Proposed Solar Farm on Land East of Pelham Substation, Maggots End, Manuden

Application Ref: S62A/2022/0011

Representation on Landscape and Visual Effects

Pelham Springs Solar Farm
Figure 1:
 Historic Landscape Characterisation and Contours

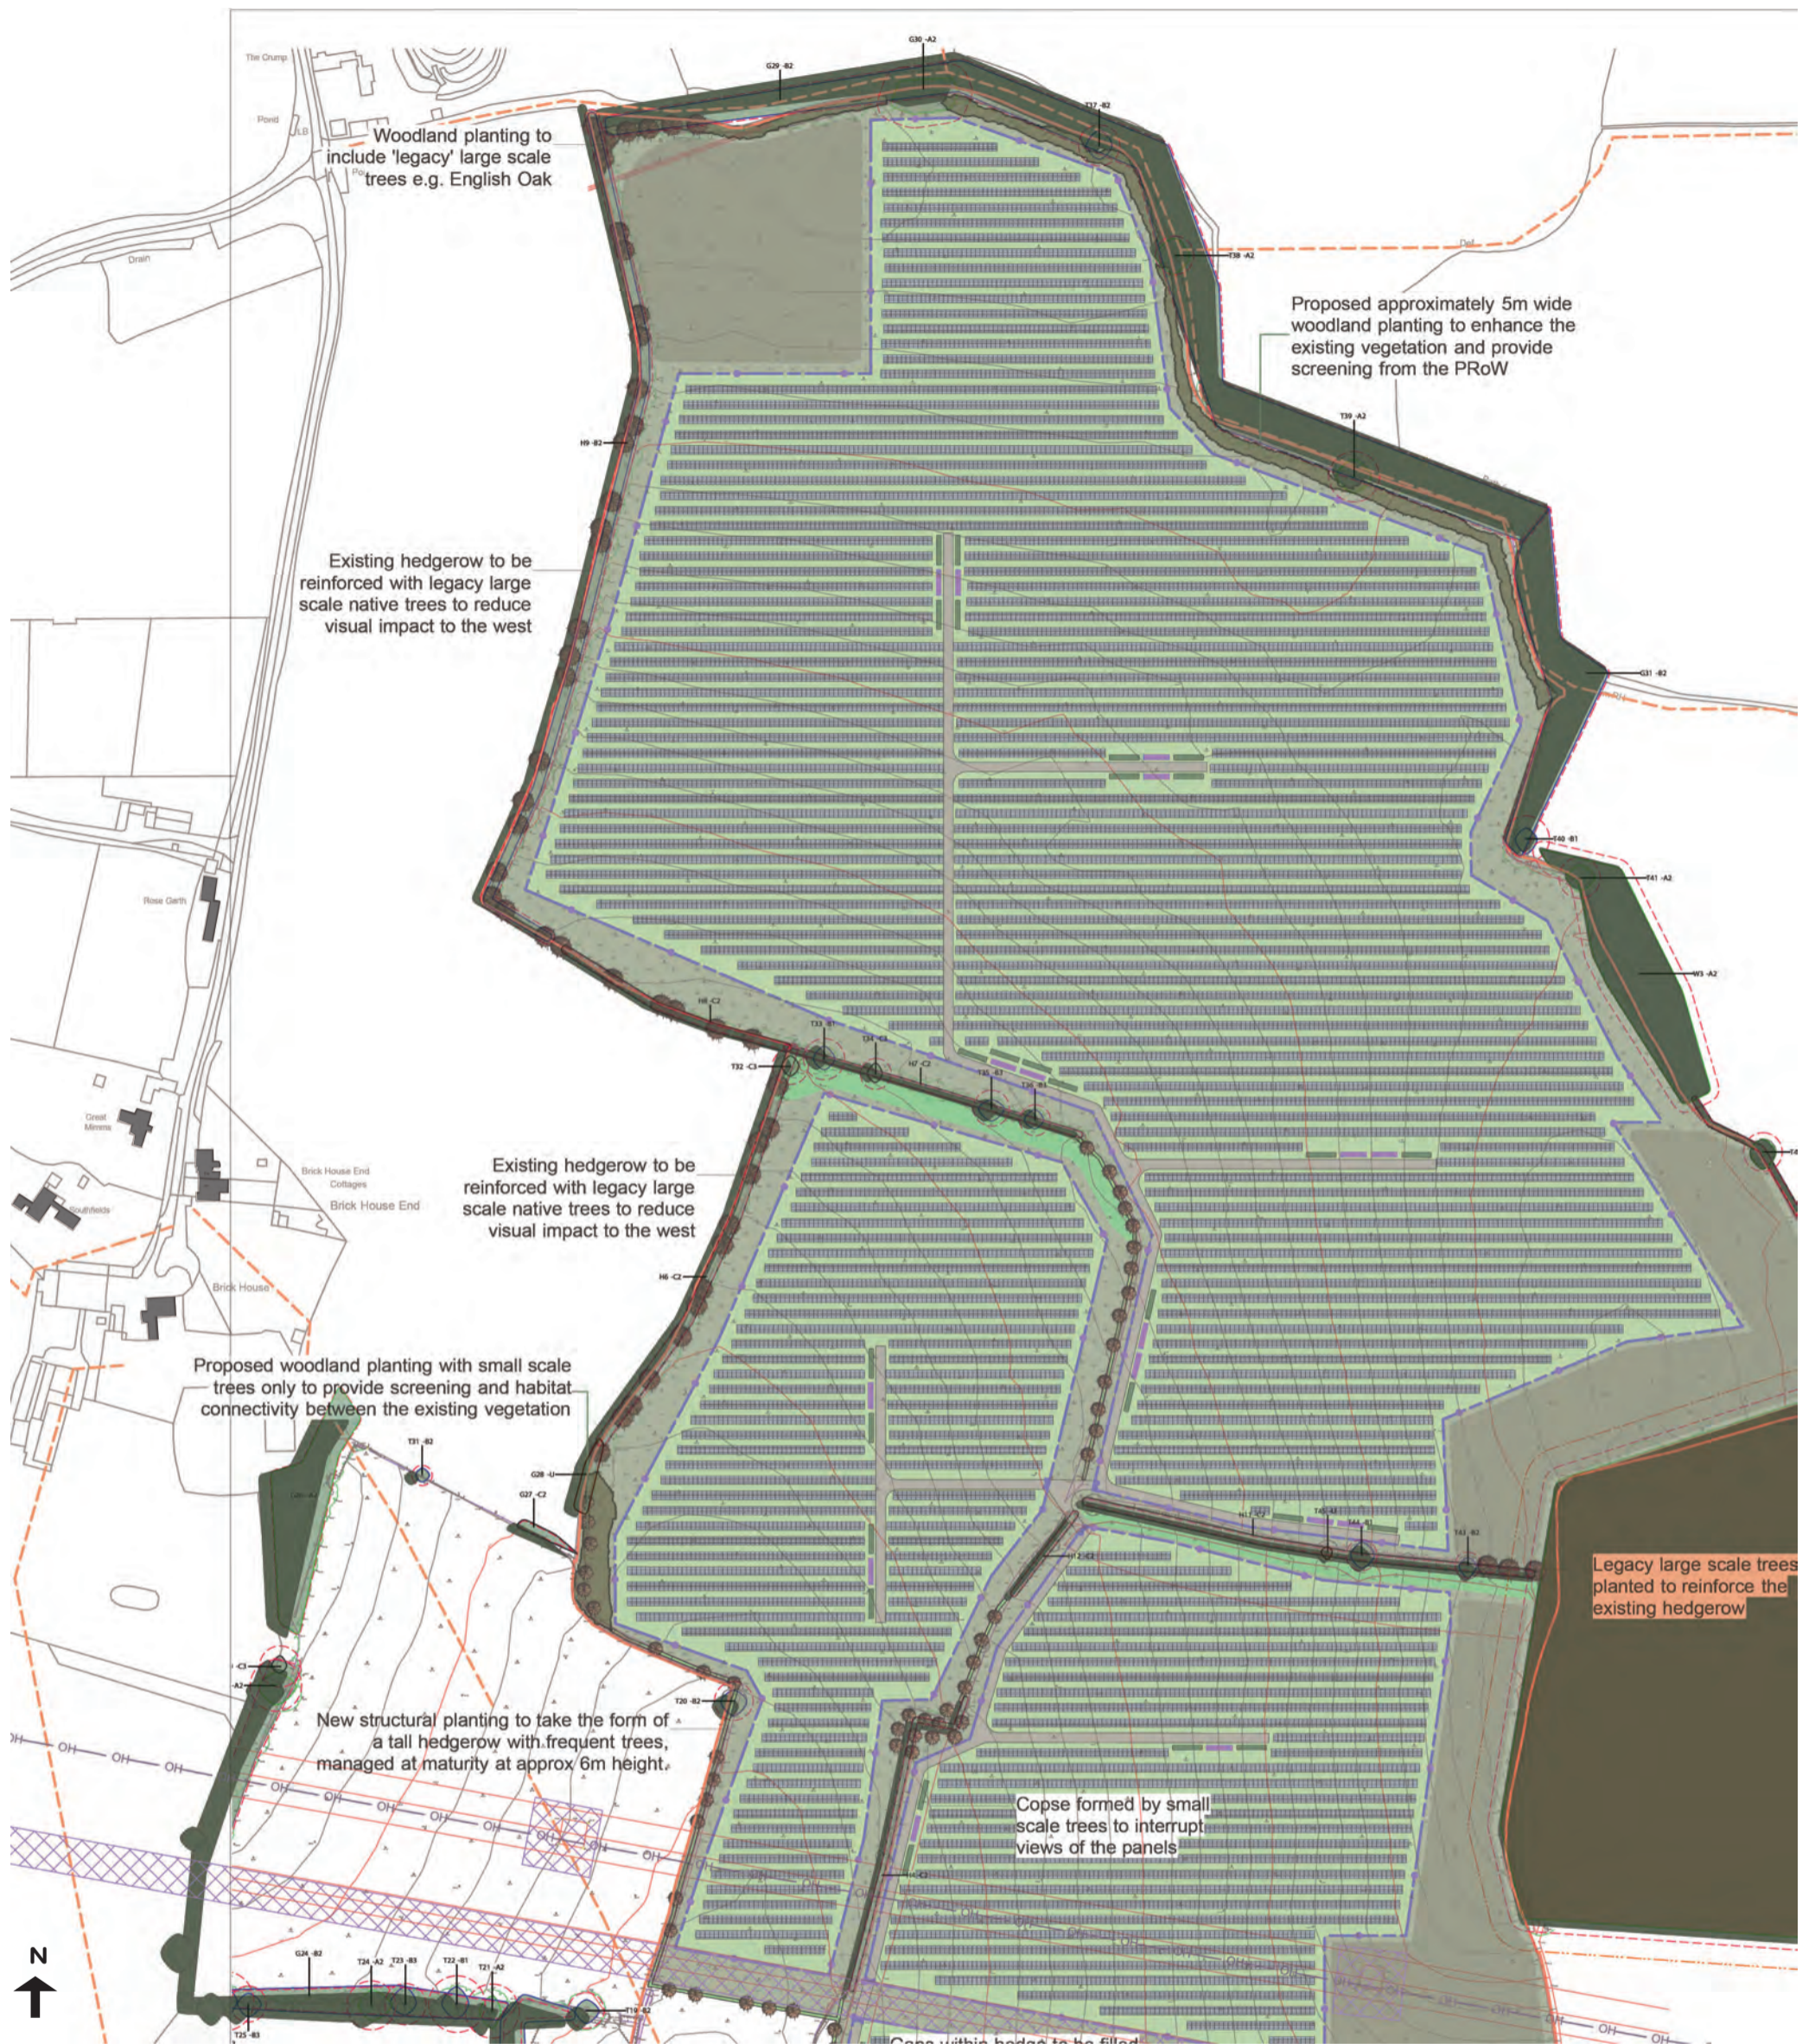
- 3.1.2 The highest point of the site is c. 122m AOD in the northern-western extremity of the site and c. 118m AOD in the northern and eastern edges of the site. Topography slopes inward to around c. 102m AOD at the southern edge of the site where the access road is proposed. The slopes are most pronounced between Battles Wood and Brick House End (refer to Figure 1 of this report).

- 5.1.4 Chapter 6 provides no mapping of the Historic Landscape Characterisation for Essex which illustrates the range of historic enclosure patterns within the site and surrounding landscape including early enclosure patterns reflecting pre 18th Century irregular enclosures and areas of post 1950s boundary loss, as well as historic woodland including Pump Springs Wood and Battle’s Wood and historic routes. Nor is there a map of local natural and cultural features - elements of the landscape which contribute to local character and sense of place. The Heritage Statement does include a series of maps showing heritage designations and features including listed building and scheduled monuments which lie within the immediate vicinity of the proposed development, but these are not referred to in Chapter 6. The historic map below and aerial photograph (appendix 2) illustrate the small-scale historic landscape enclosure pattern which remains intact south of Brick House End, as well as historic routes and settlement pattern.

Figure 8: Map showing Habitat/Boundary Zones

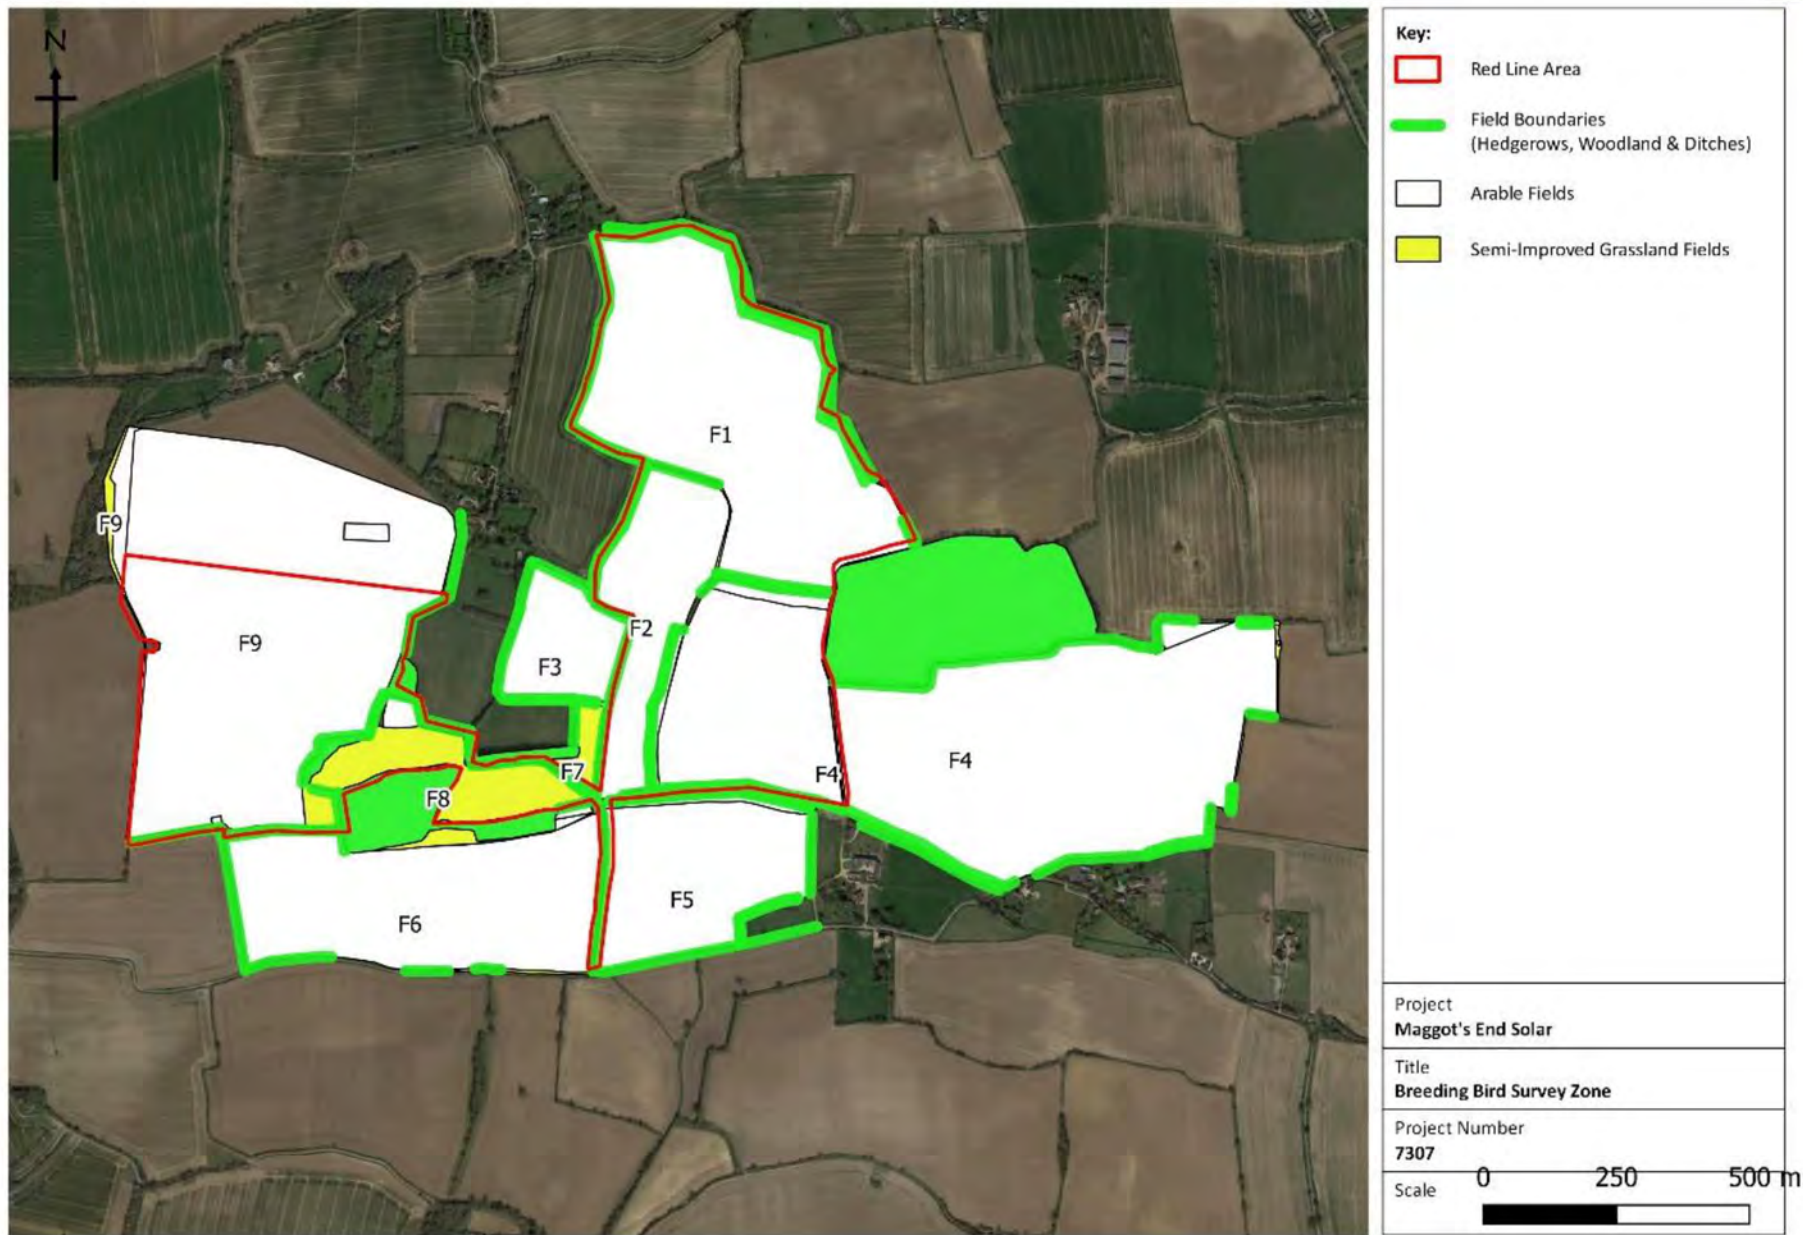
- 6.2.2 In terms of landcover the assessment describes the grassland in Zones 1 and 6 as comprising improved grassland however reference to the Phase 1 Habitat Survey shows that it is semi-improved grassland - refer to Figure 8 of Ecological Assessment and paras 2.5.11- 2.5.14 (copied at Appendix 2 of this report for convenience). The Ecological Survey stated that *'The semi-improved grassland on site has a modest floristic diversity...overall the semi-improved grassland habitat was considered to be a site of ecological importance.'*
